Source: Leece-Neville Heavy Duty Systems Division - Arcade, NY USA
Date: July 7, 2017
Bulletin No: TSB-1052
Models: 4900 Series Alternators
Subject: Alternator Clearance Issue on Mercedes 926 Engines

Bracket depicting area of interference

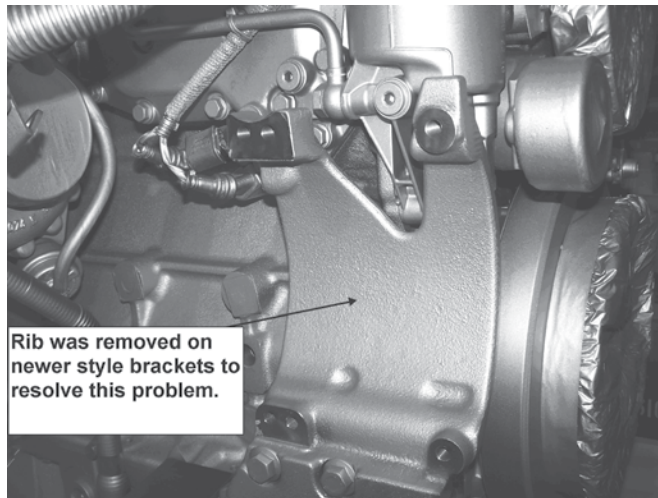
On some Mercedes 926 (190-260 HP) engines, the engine bracket which the alternator mounts onto will not accommodate some Leece Neville 4900 series alternators. The detail below illustrates the abutment that is present on a limited number of engines.

Limited production bracket with abutment

Current production mounting bracket

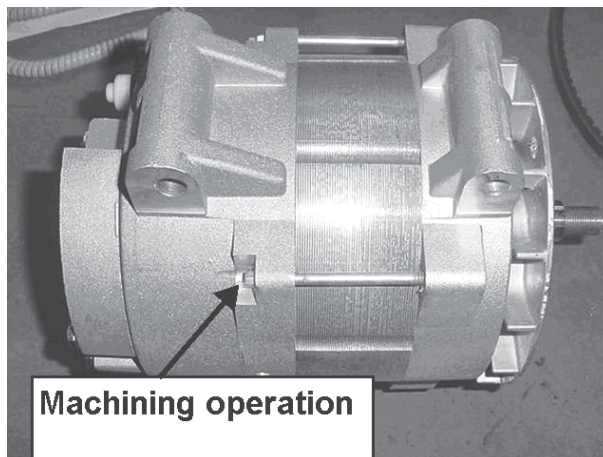
If your engine has this bracket, Leece Neville modified the housing through an additional machining process to resolve this problem for an interim time period to resolve this issue prior to the engine manufacture modifying the bracket. Below are pictures showing the modification made by Leece Neville.

The alternator applicable to this application is Leece Neville part A0014939PGH 14 volt 185 amp alternator.

Note: This clearance issue only exists on Leece Neville 4900 series (185 amps to 320 amps) alternators. All other Leece Neville alternators do not have this problem and will fit on this bracket.
